Access Compliance Report

Public Rights-of-Way

(Curb Ramps)

Intersection ID: 10019556	Main Street: ALMA_BLOUNT_BV	Cross Street: N/A	Location: SE
ADA ID: D25C8A58F637	Ramp Type: PerpDiag	Initial Pass/Fail: Fail	Overall Compliance: No
Codes/Mitigation Info/Possible Solution		Field Measurements/Component Compliance	
Severity Score: 8.75

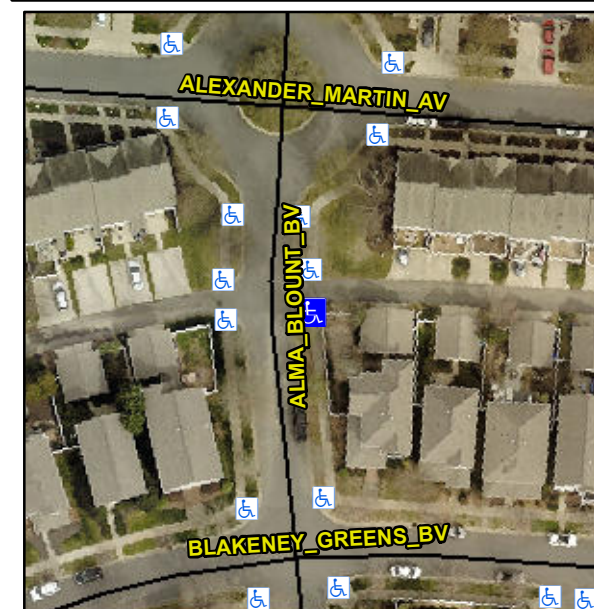
R304.5.1

Compliance	Description	Data	Compliance	Description	Data
N/A	Ramp Length (in)	90.0	Yes	Ramp Slope (%)	2.6
No	Ramp Width (in)	44.0	Yes	Ramp XSlope (%)	1.4
N/A	Flare Type LT	N/A	N/A	Flare Type RT	N/A
N/A	Flare Slope LT (%)	N/A	N/A	Flare Slope RT (%)	N/A
N/A	Flare Traversable LT?	N/A	N/A	Flare Traversable RT?	N/A
N/A	Landing Length (in)	N/A	N/A	DWS Provided?	N/A
N/A	Landing Width (in)	N/A	N/A	DWS Contrast?	N/A
N/A	Landing Slope (%)	N/A	N/A	DWS Length (in)	N/A
N/A	Landing X Slope (%)	N/A	N/A	DWS Full Width?	N/A
N/A	Landing Curb? (Y/N)	N/A	N/A	DWS Offset (in)	N/A
N/A	Shared Landing?	N/A			
N/A	Gutter Ponding?	N/A	N/A	Gutter Slope (%)	N/A
N/A	Gutter Lip Ht (in)	N/A	N/A	Gutter X Slope (%)	N/A
N/A	Painted X Walk1?	No	N/A	Painted X Walk2?	No
	X Walk 1 Direction	To N		X Walk 2 Direction	To W
N/A	X Walk 1 Width (in)	N/A	N/A	X Walk 2 Width (in)	N/A
	X Walk 1 Slope (%)	1.6		X Walk 2 Slope (%)	0.1
	X Walk 1 X Slope (%)	3.5		X Walk 2 X Slope (%)	0.7

Remove & Replace Curb Ramp With Two New Directional Ramps or Equivalent.
